PLOT PLAN

LOT 73
The Estates at Rolling Hills Ranch Filing No. 2
EL PASO COUNTY, COLORADO

11203 ESTATE RIDGE DRIVE

ERH2-73

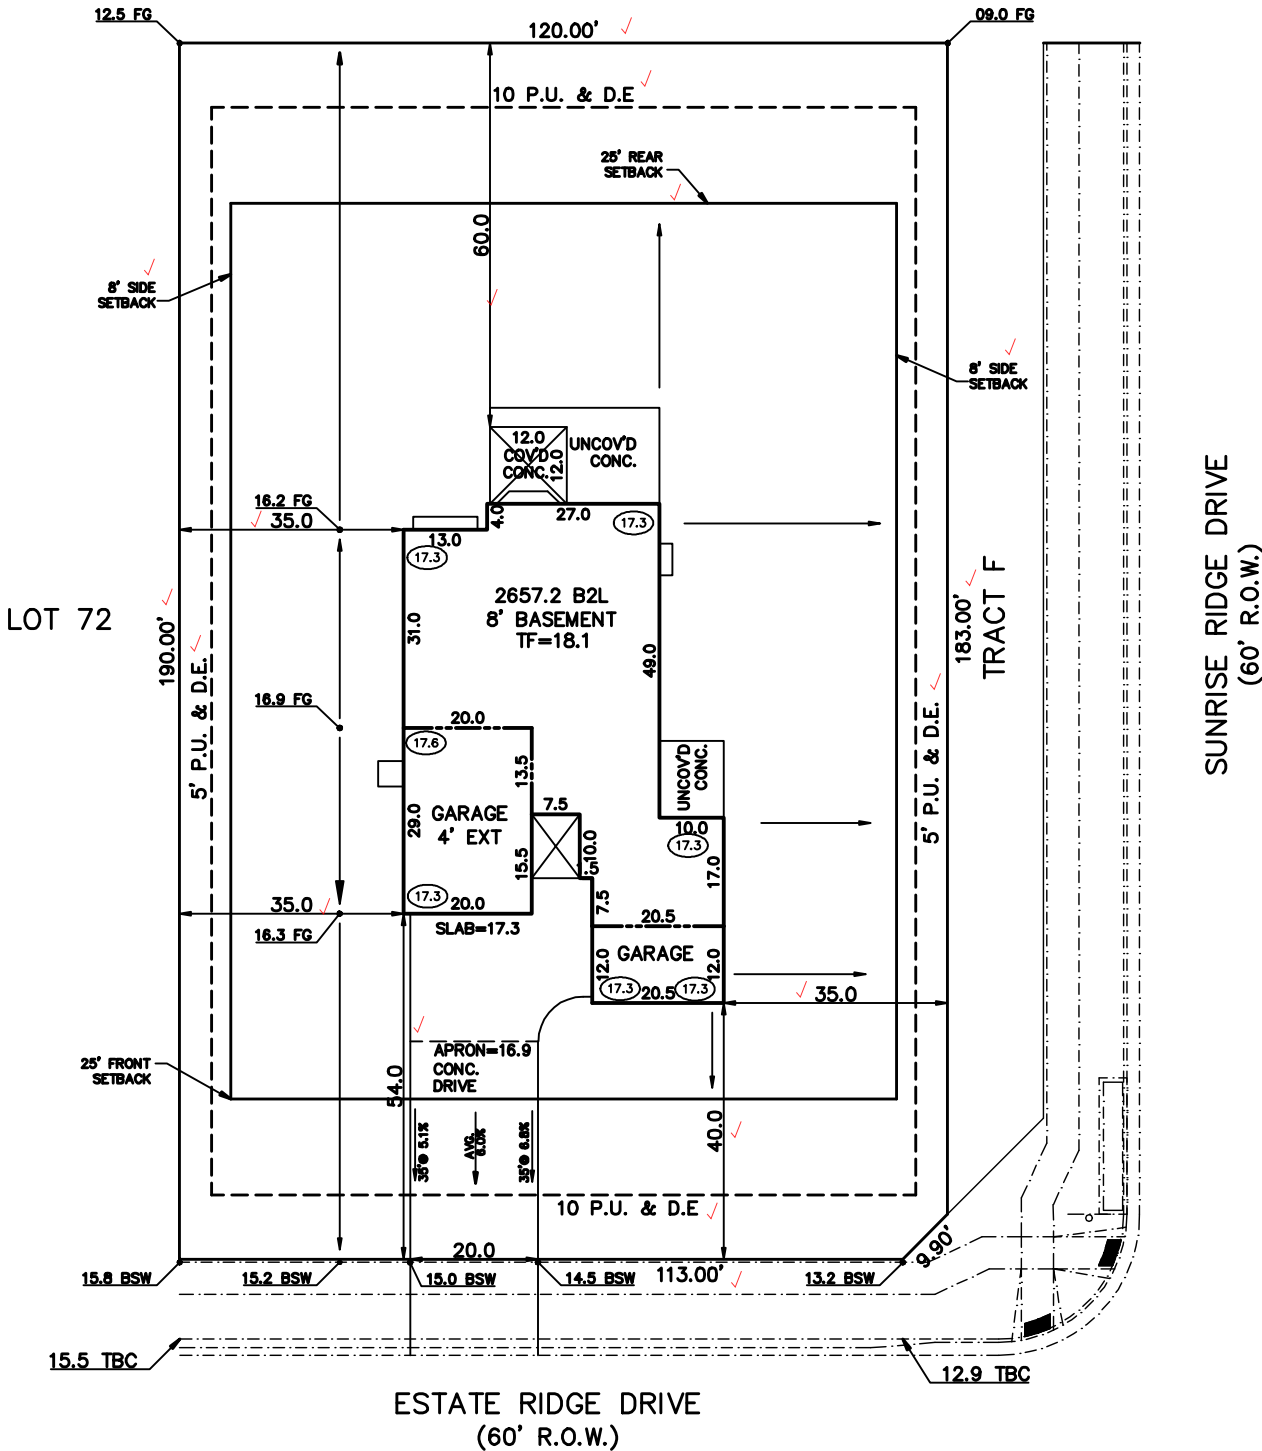
This parcel is in a low/moderate/high intensity fire risk area. Please reach out to the local fire district regarding recommendations for compliance with the WRC code.

It is the owner's responsibility to coordinate with easement holders to avoid impact to utilities that may be located in the easements.
